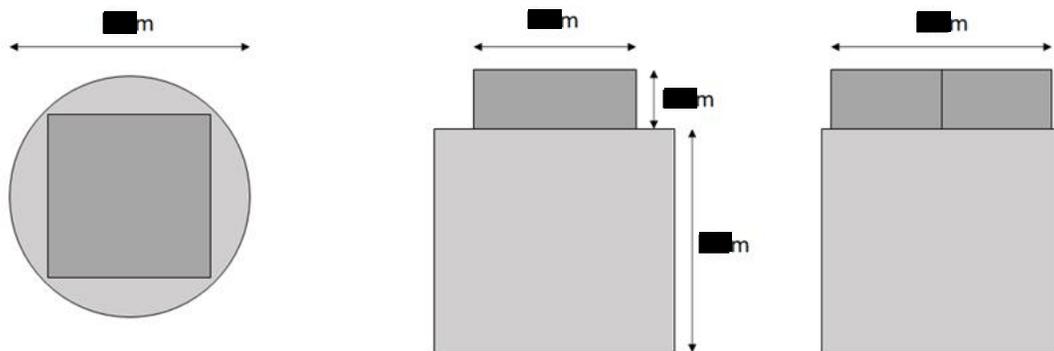
3. Please provide additional information on the Control Sat component of the spacecraft. What is the mass, shape and material composition of the object? Is it nested inside the spacecraft itself, and if so how deeply, providing protection/delay from normal reentry conditions?

RESPONSE: The ControlSat is the structural box that contains all of the major subsystem elements of the satellite. This includes avionics, propulsion, attitude determination and control system (ADCS), communications, and electrical power subsystems (EPS). The ControlSat structure is external and interfaces with the phased array. In the worst case scenario, where the ControlSat does not demise on re-entry, the total casualty risk does not exceed the 1:10,000 requirement. The ControlSat and phased array together represent a total risk assessment of 1:19,700.
